Our Ref: 1731/PJ/111214

11 December 2014

Re: Response to Office of Environment and Heritage, Department of the Environment and the Greater Blue Mountains World Heritage Advisory Committee Comments on the Tinda Creek Sand Extraction State Significant Development Proposal

FIGURE 7

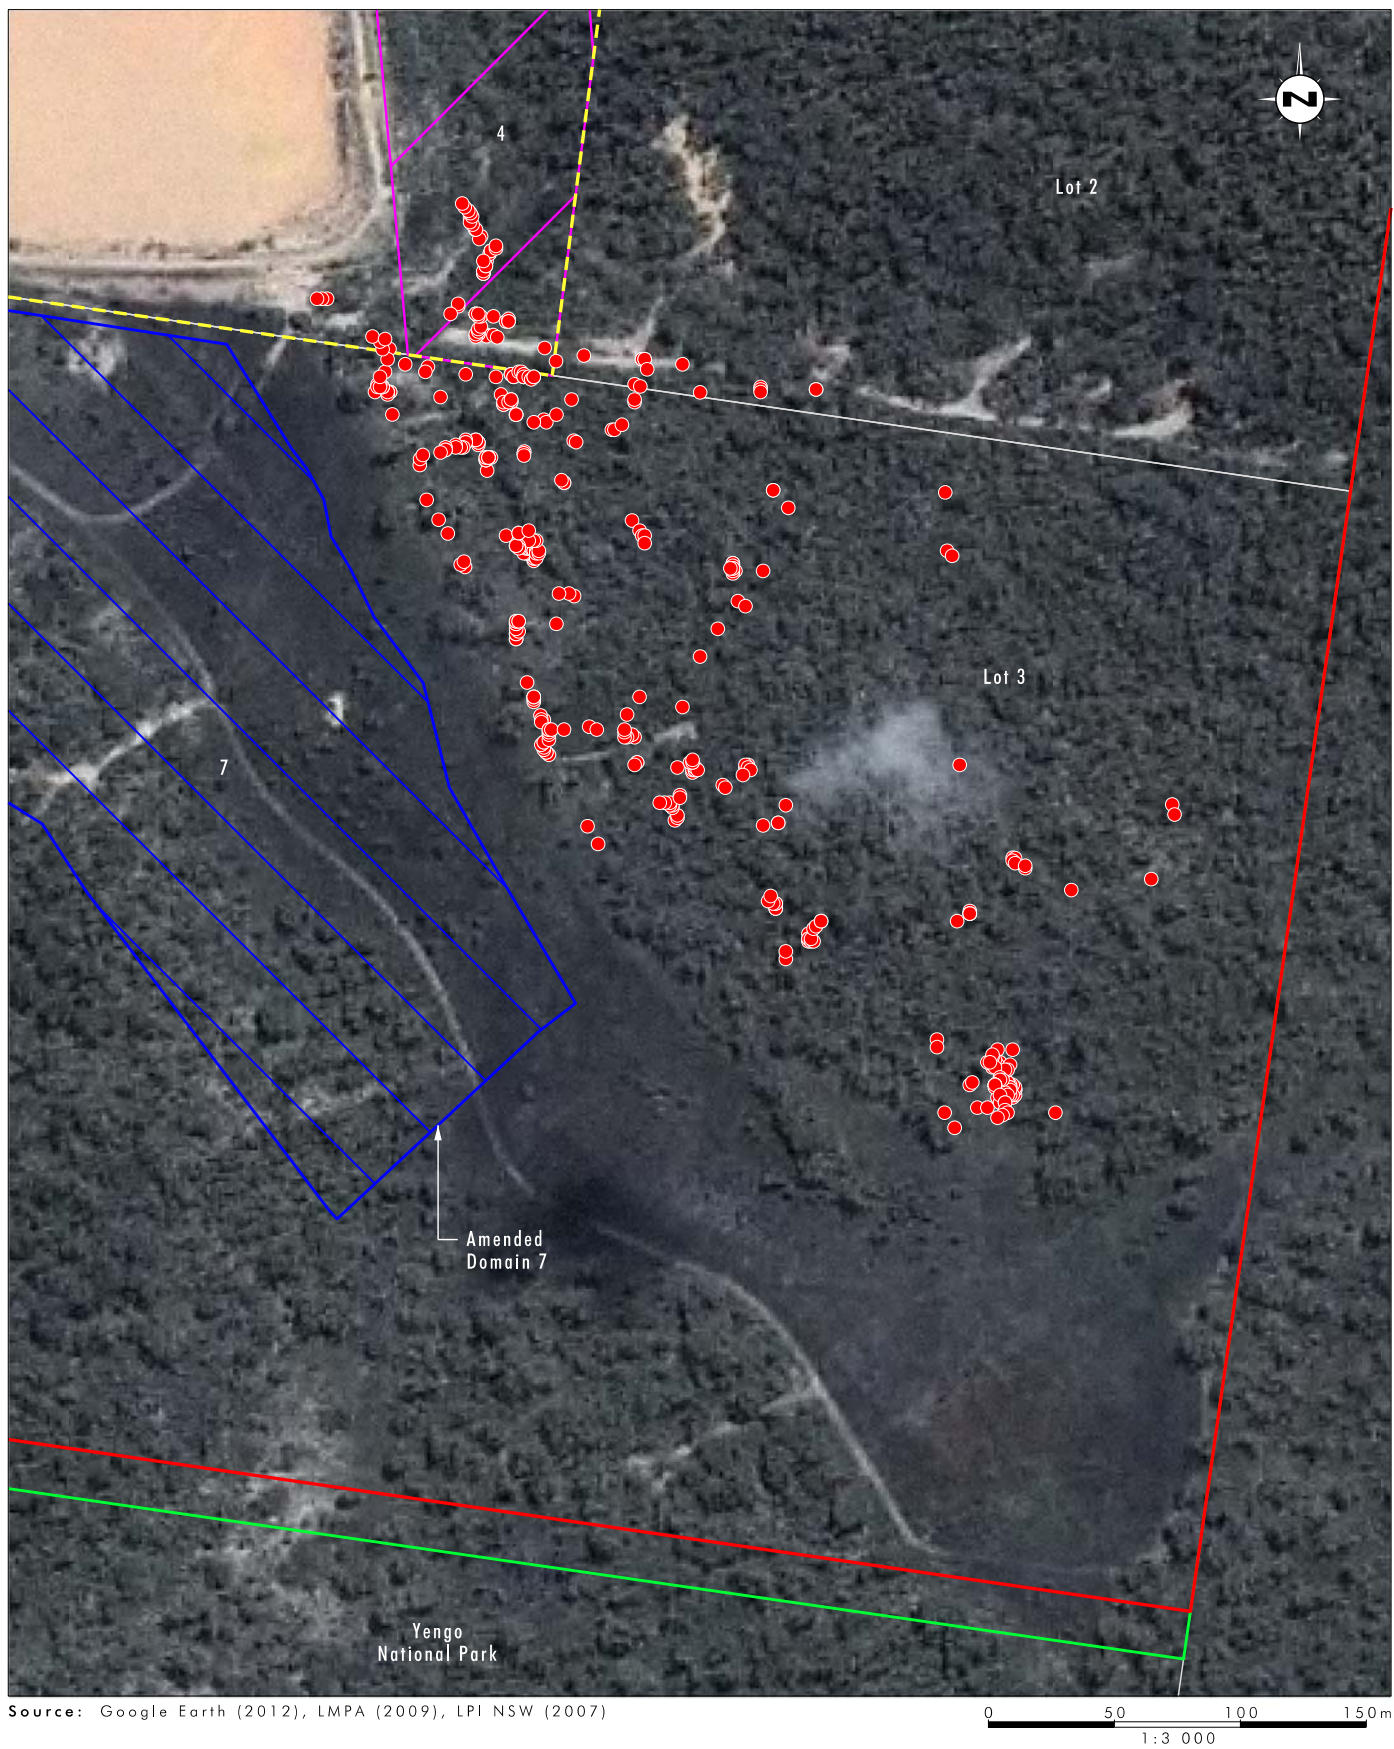
3. The domain 7 option provides for a ten metre buffer zone between the quarry and the proposed offsets area (see p7.9 of EIS Appendix 7). The Department requests further information be provided demonstrating that this would be effective in avoiding direct impacts to <i>Grevillea parviflora</i> beyond the buffer. This should include information on how the buffer will be managed for ecological benefit and the activities and access that will be allowed in the buffer.	Figures 6 and 7 provide a higher resolution representation of the locations of individual <i>Grevillea parviflora</i> subsp. <i>parviflora</i> in relation to the extractions areas in Domains 3 and 7. As shown on Figure 7, extensive areas of <i>Grevillea parviflora</i> subsp. <i>parviflora</i> occur in close proximity to active quarry areas and disturbed tracks, which supports the assertion that existing quarry operations have limited indirect impacts on adjacent habitats, including habitat for <i>Grevillea parviflora</i> subsp. <i>parviflora</i>.

As discussed above, the proponent has avoided direct impact on 845 recorded *Grevillea parviflora* subsp. *parviflora* with only three individuals being impacted. All of the known *Grevillea parviflora* subsp. *parviflora* are located at least 40 metres from the proposed extraction area in Domain 7. While quarrying is proposed to occur within 40 metres of the closest occurrence of *Grevillea parviflora* subsp. *parviflora* (except for the three in Domain 3 that will be impacted), as shown on **Figure 7** existing quarry activities have been occurring within 10 metres of known *Grevillea parviflora* subsp. *parviflora* and no adverse effects were noted during field surveys. The proponent will implement a suitable program to monitor the ongoing health and condition of remnant *Grevillea parviflora* subsp. *parviflora* which will be documented in an approved management plan.
